World Forum for Harmonization of Vehicle Regulations**Working Party on Automated/Autonomous and Connected Vehicles****Ninth session**

UN Regulation No. 79 (Steering equipment):**Automatically Commanded Steering Function****Proposal for a supplement to the 03 series of amendments to
UN Regulation No. 79 (Steering equipment)****Submitted by the expert from European Association for
Electromobility***

ACSF C – Case where the lateral movement is initiated automatically (1 Step HMI)

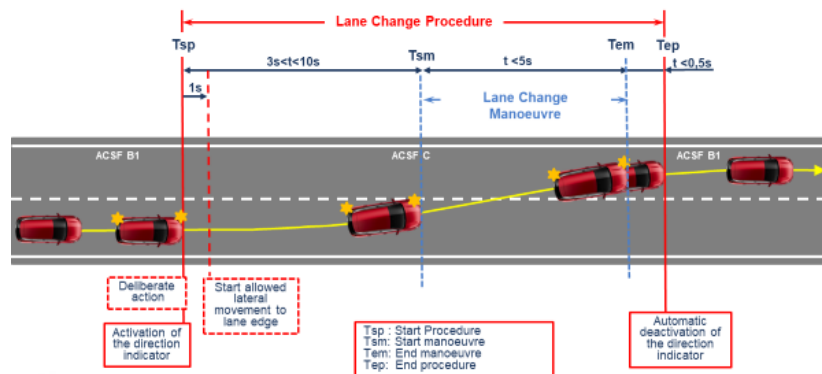
In case of an automatic initiation the lane change manoeuvre shall commence between 3.0 seconds and 7.0 5.0 seconds after the manual activation of the procedure as described in paragraph 5.6.4.6.2. and shown in the Figure below. **The manoeuvre shall commence at the earliest opportunity when the situation is not deemed critical as defined in 5.6.4.7.**

ACSF C – Case where the lateral movement is initiated by a second deliberate action by the driver (2 Step HMI)

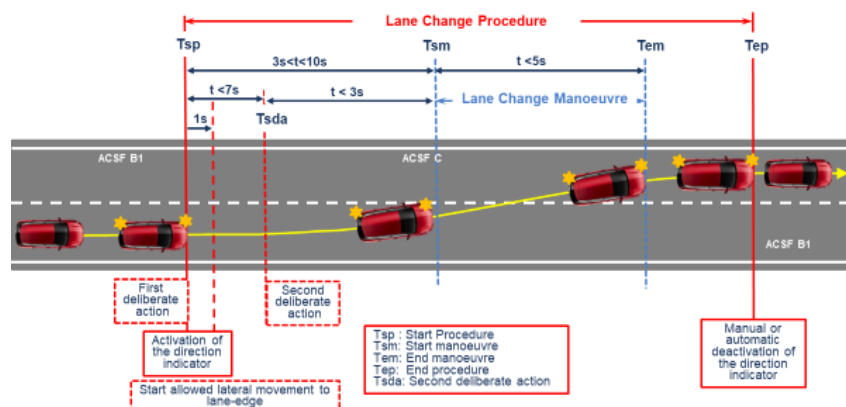
In case of an initiation by a second deliberate action the lane change manoeuvre shall commence between 3.0 and 7.0 7.0 seconds after the manual activation of the procedure as described in paragraph 5.6.4.6.2.

Additionally, the lane change manoeuvre shall commence at the latest 3.0 seconds after the second deliberate action as shown in the Figure below.
